Informal document **GRVA-09-17**
9th GRVA, 1-5 February 2021
Provisional agenda item 7

Proposal to amend the PBC reference for AEBS M1/N1

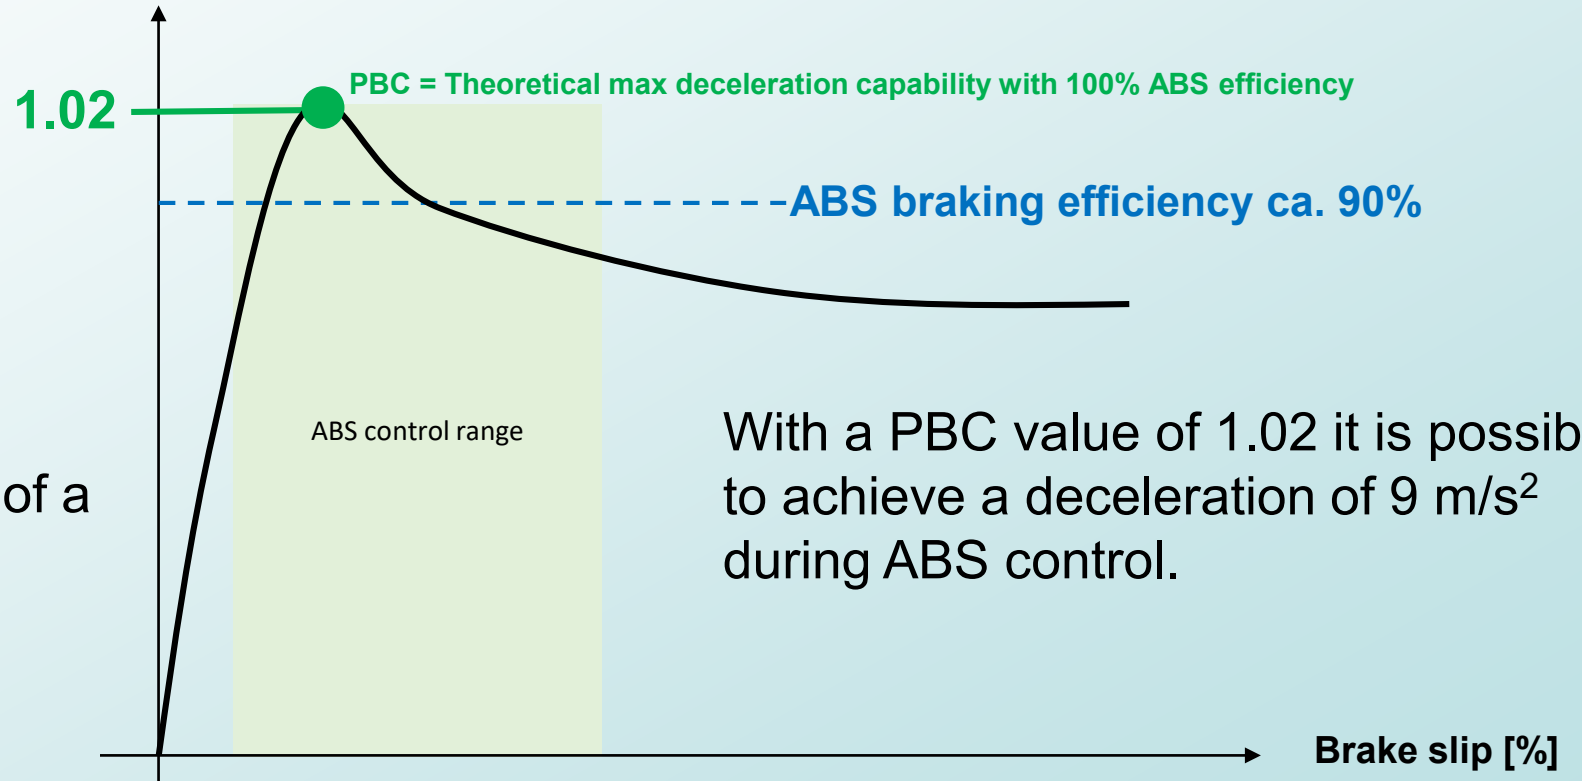
- The ASTM E1337-90 determines a conversion factor, because tests with different tyres (e.g. E1136 or F2493) on the same track will result in different PBC values.

- Example - a of PBC 0.9 based on the E1136 can be converted to 1.017 with the **F2493 tyre as follows:**

$$(0.9 \times 1.17) - 0.0360 = 1.017. \rightarrow \mathbf{1.017 \text{ is the preferred PBC using the ASTM method}}$$

PBC = 0.9 with „old“ ASTM standard reference tire E1136 (P195/75R14)

PBC = 1.017 with „new“ ASTM standard reference tire F2493 (P225/60R16 97S)
